**PLANNING COMMISSION
SITE PLAN COMPATIBILITY WAIVER REQUEST REVIEW SHEET**

CASE: SP-2013-0484CS

PLANNING COMMISSION DATE: June 10, 2014

PROJECT NAME: 1106 Lambie Street

**1106 LAMBIE STREET
 SITE PLAN/DIMENSION CONTROL PLAN**

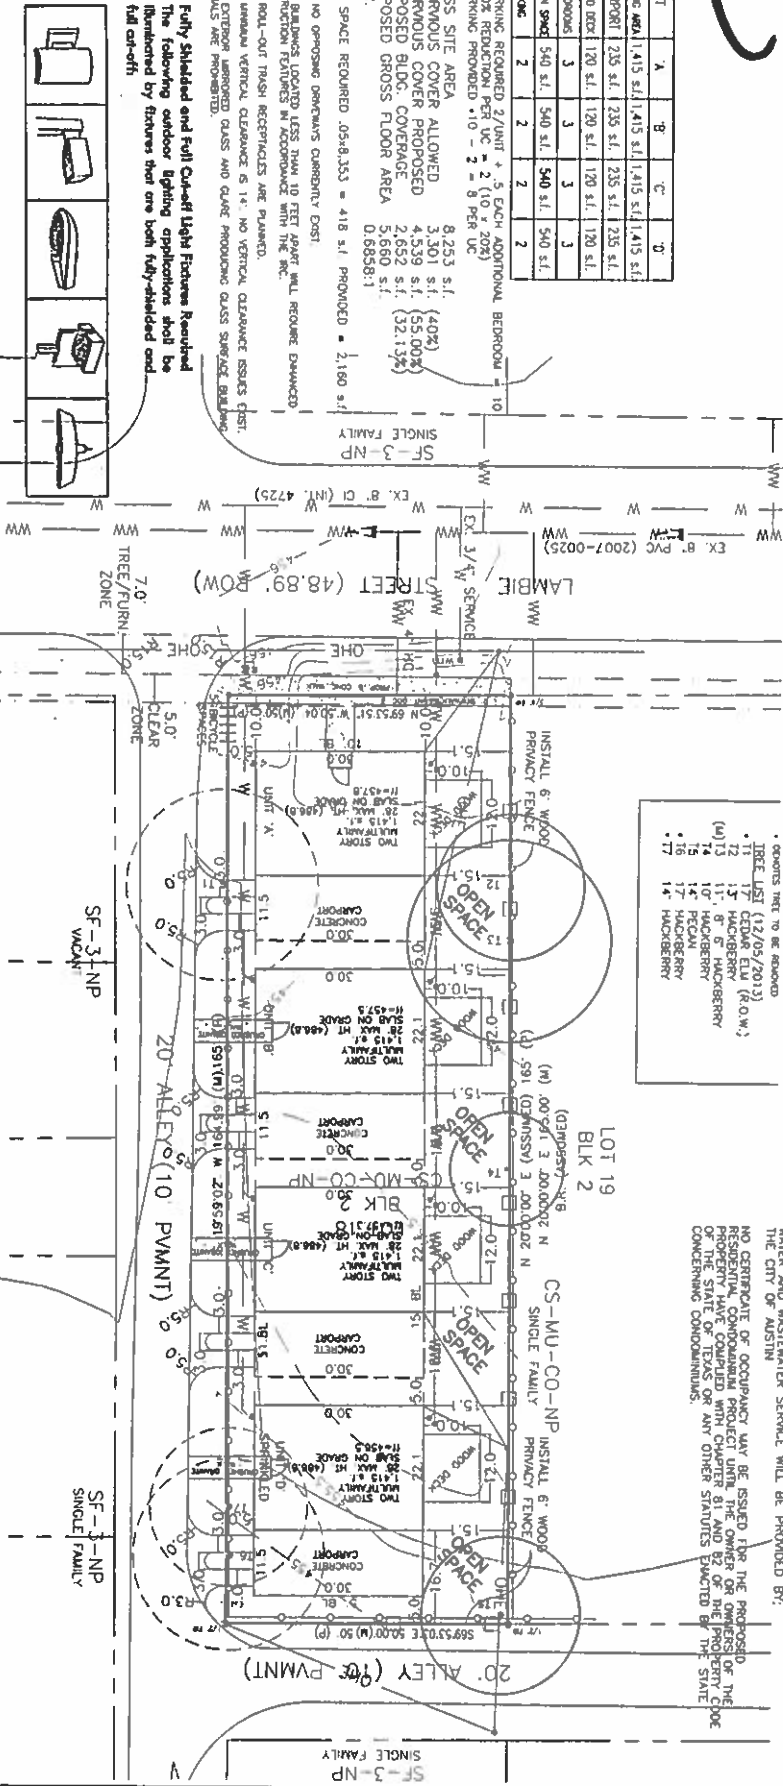
Waiver request is as follows: LDC Section 25-2-1064 Front Setback:

The applicant requests a waiver from the 25-foot front setback to a 10-foot setback.

Waiver request is as follows: LDC Section 25-2-1062 Side Setback:

The applicant requests a waiver from the 15-foot side setback to a 5-foot setback in order to allow for rear wooden decks behind each unit.

Staff recommends approval of the waiver from LDC Section 25-2-1064 to reduce the front yard setback from 25 feet to 10 feet. Additionally, this is a narrow site and would be considered a small site under compatibility regulations. While compatibility regulations have an accommodating range of side and rear setbacks for small sites, all sites adjacent to single-family have a 25-foot front setback requirement, regardless of the site size. Finally, this site has a base zoning of CS, which, under Subchapter E requirements, would otherwise require the building to be pulled up to the sidewalk, in order to encourage engagement between the building and the streetscape.

Staff recommends approval of the waiver from LDC Section 25-2-1062 to reduce the side yard setback from 15 feet to 5 feet. The buildings maintain a 15 foot minimum setback as required. The compatibility waiver is to allow for uncovered wood decks in the rear yard of each unit.
